20-COA-0181
515 W. Oak St.

Old Louisville Architectural Review Committee
Public Hearing

Bradley Fister, Historic Preservation Specialist
October 14, 2020

01 ENLARGED
FIRST FLOOR PLAN
SK01-01 3/16" = 1'-0" NORTH

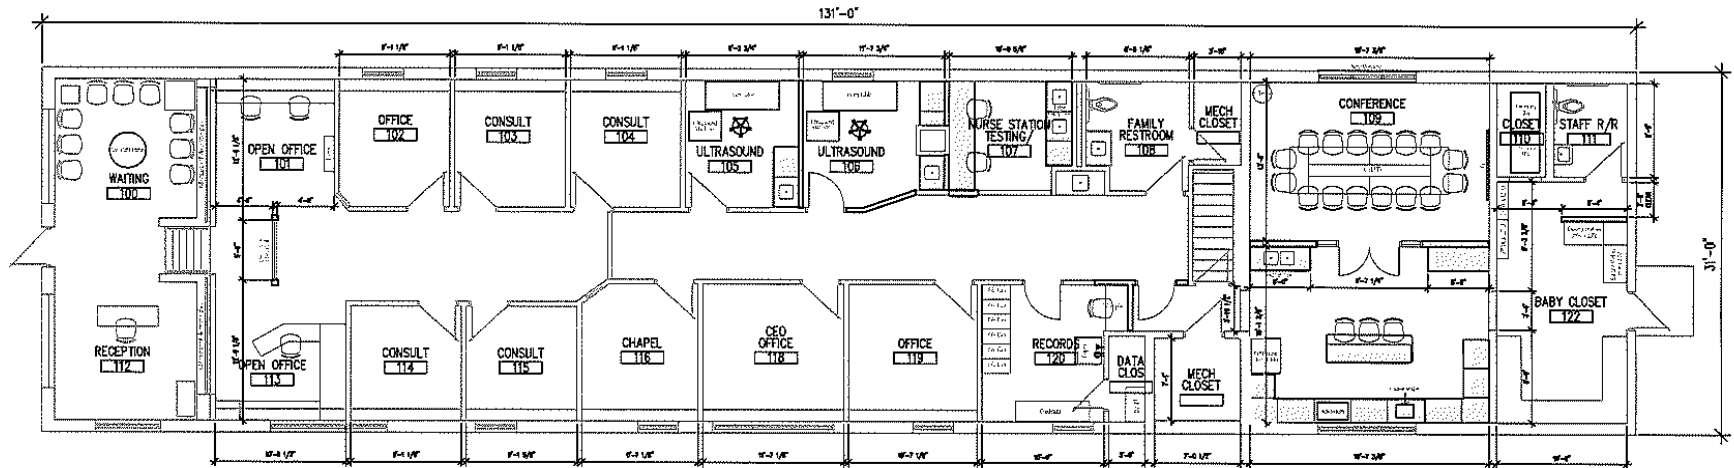
The removal of the flat roof, brick side panels, and masonry planters are not in conformance with the **Storefront Design Guidelines**. Which states in **SF1** not to remove historic elements from front facades. Though the reasons behind removal of the proposed historic elements are not unfounded, **SF3** states to retain all historic storefront elements.

The removal of said elements would also change the scale and proportion of the building as a whole, which is discouraged in **SF6**. The proposal in regard to the **Paint Design Guidelines**, the non-painted masonry conflicts with **P1**, which states not to paint masonry that has not previously painted. The project generally meets the Design guidelines for **Site**, in regard to if the project is approved, the changes would be complementary in nature per **ST1**.

On the basis of the information furnished by the applicant, the application for a Certificate of Appropriateness is recommended for **Denial**, however if the Committee were to find the changes appropriate, staff recommends the following conditions:

1. The applicant shall not paint the masonry on the front façade per **P1**.
2. The applicant shall photographically document the existing façade prior to removing any historic elements.
3. If the design changes, the applicant shall contact staff for review and approval.

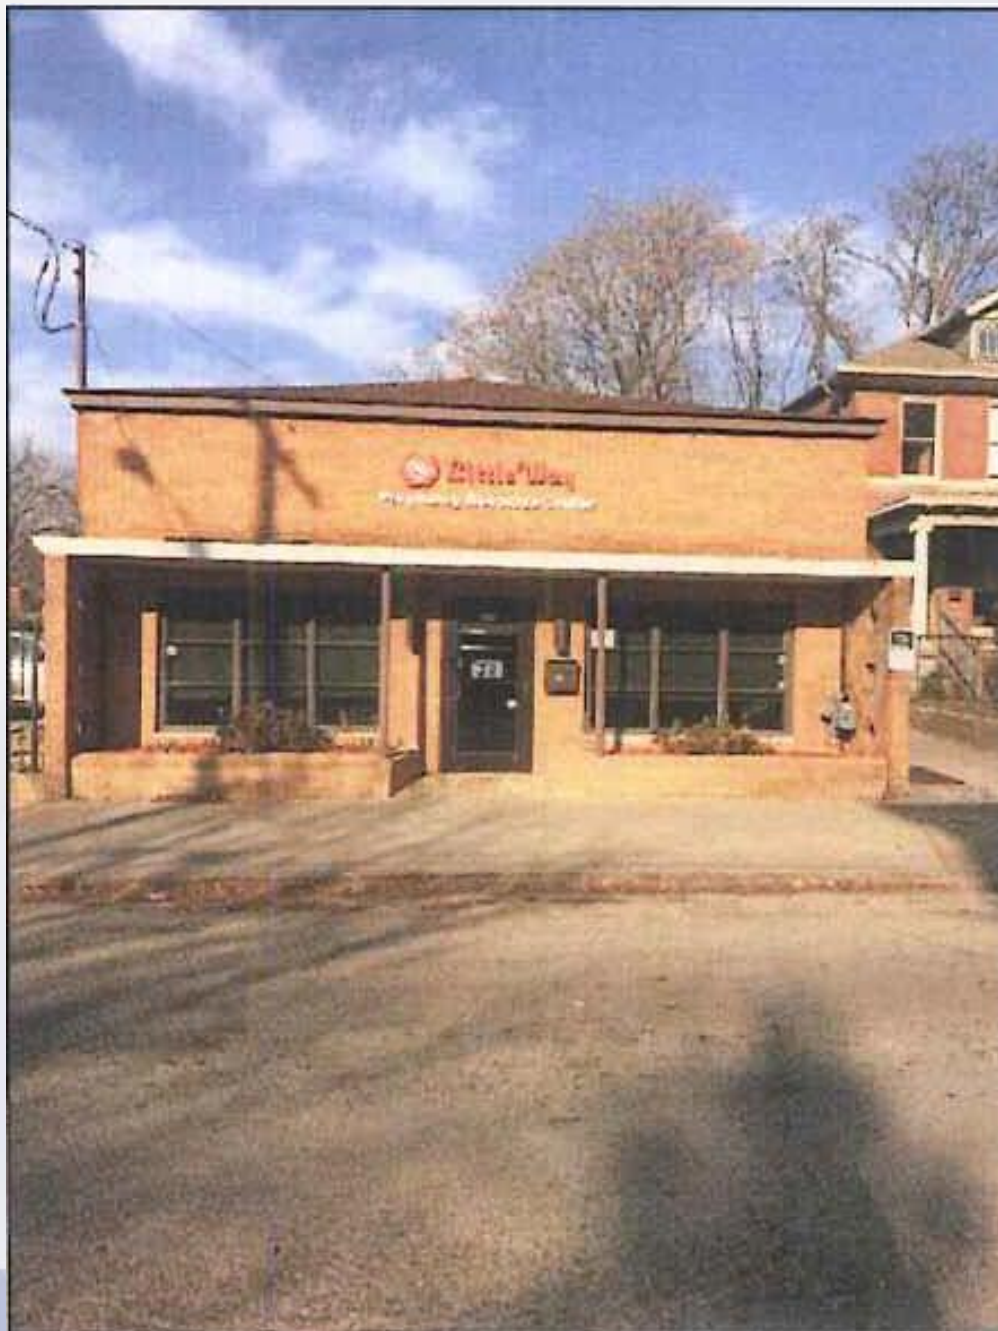
1. Photo shows driver's vision as you approach the end of Little Way driveway and pedestrian sidewalk.

2. Here is a car at the end of Little Way driveway. Driver is unable to see any pedestrians or bikers until very last minute, because brick panels impede vision.

3. Driver is often surprised by biker or pedestrian on the sidewalk at the end of Little Way driveway due to impeded vision.
